June 29, 2013

Re: trees at Pierce Queen

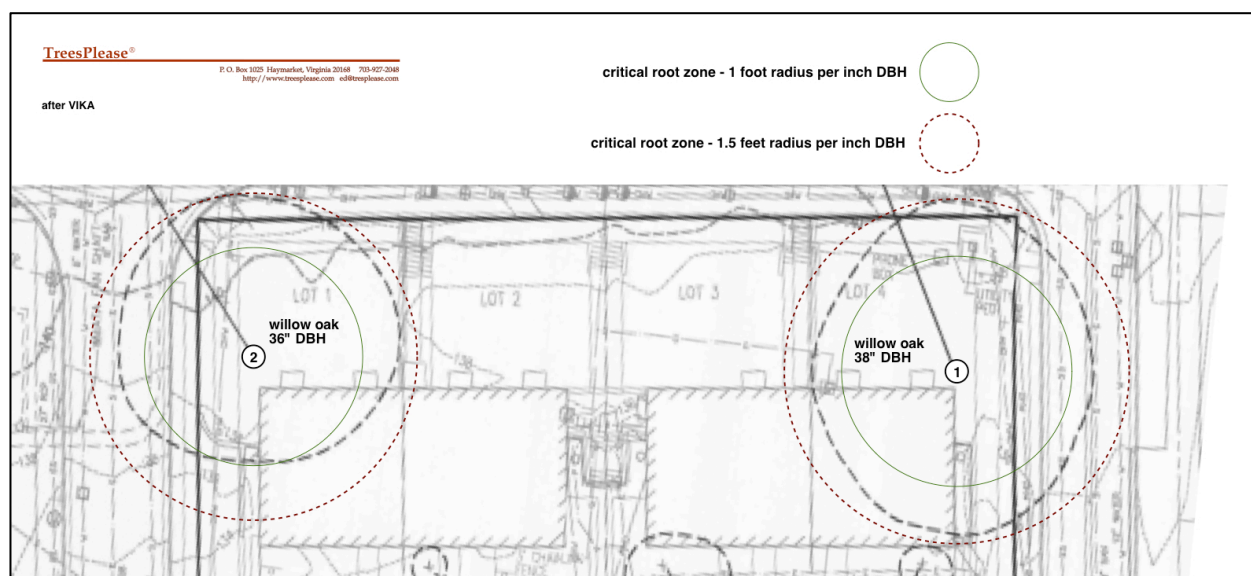
The two trees are shown in this drawing, along with their critical root zones (CRZ). While one cannot know exactly where a tree's roots have grown without removing all the

It is apparent that these two trees have their CRZs constrained by pavement and building footprints. An analogy that may be useful to understand the ramifications of this is to think of a tree's CRZ as a balloon. If walls and pavement inhibit the balloon's expansion, it still occupies the same volume – it simply bubbles out into the open space.

In such a situation, experience is that the trees' roots grow preferentially into whatever open ground is available. Therefore, when grading alters such open ground, one must assume that tree roots are being damaged or destroyed even though the changes occurred outside that theoretical CRZ.

From what I can tell about the plans, the public and entrance sidewalk layouts will change; the sloped ground between the trees and 16th Street will change; there will be electrical utility work that trenches through and changes the grade. I do not see how all this can be done without seriously compromising the health of these two trees.

All things considered, it seems that taking out these two trees and replanting with high quality species is a good option.
